Meeting: Special Plan Commission
Place: 1293 Washington Ave, Cedarburg
Date/Time: August 27, 2025 / 7:00PM*
Web Page: www.townofcedarburgwi.gov
Posted: August 22, 2025
***This meeting is also available remotely online. For remote access, email sjacoby@townofcedarburgwi.gov for information.**

PLAN COMMISSION MEETING MEMORANDUM

GAUTHIER POND PLAN

MEMORANDUM

Date: May 21, 2025
Revised: July 21, 2025
Drawing No. 2189.10-lpm
SHEET 1 OF 9 SHEETS

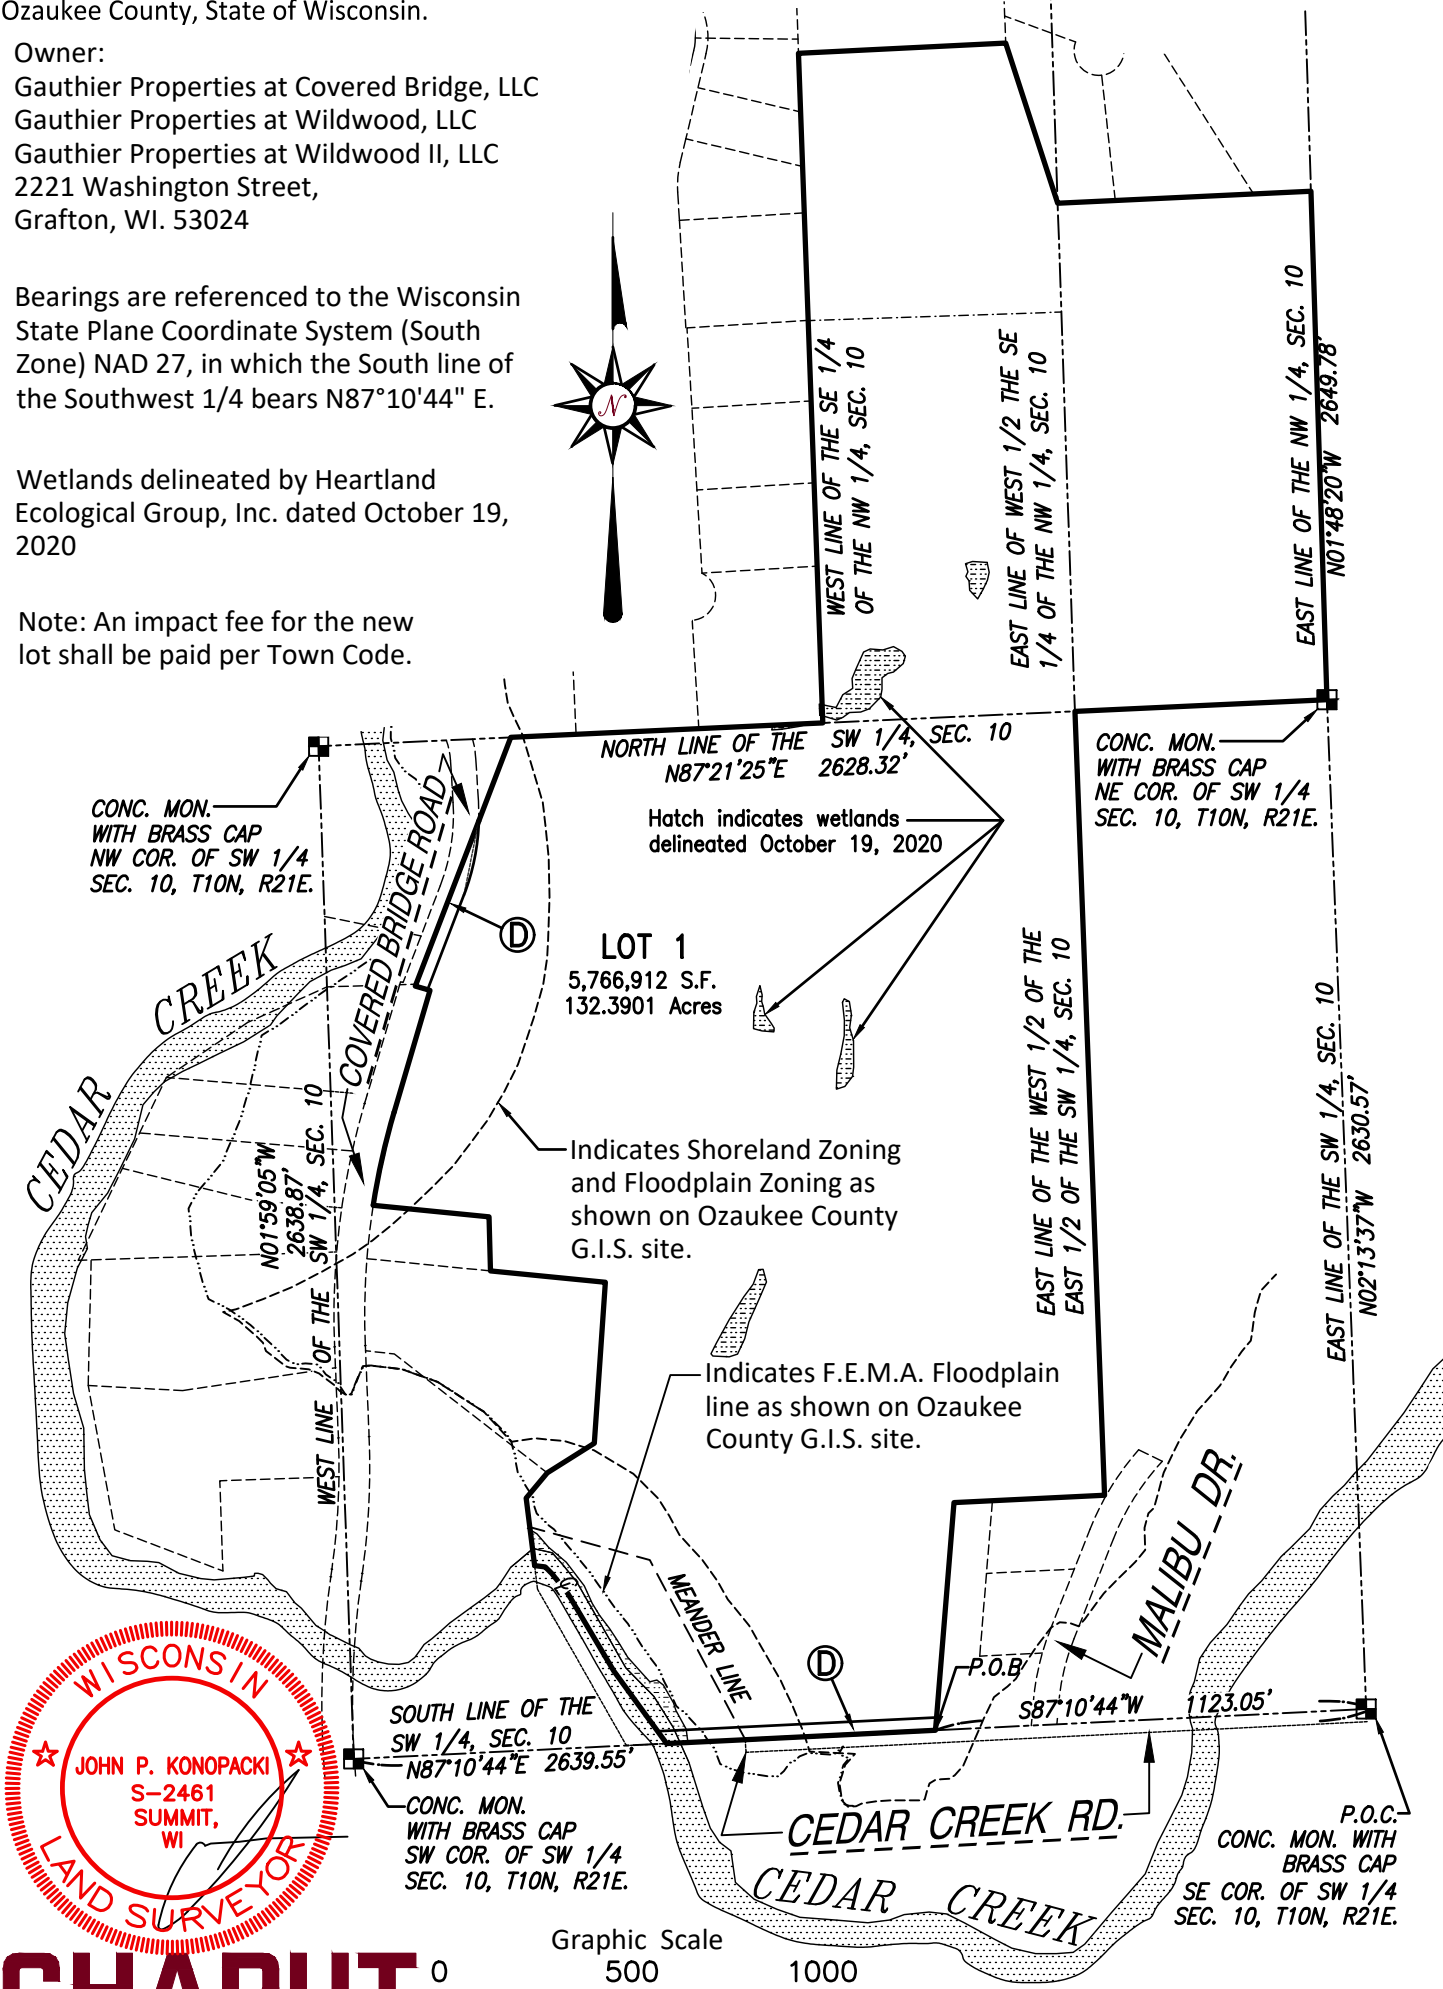
4. The amount of acreage on sheet 1 of 9 is 132.3901; while the legal description on sheet 5 Of 9 states 132.3601. Please make sure these numbers are in agreement.
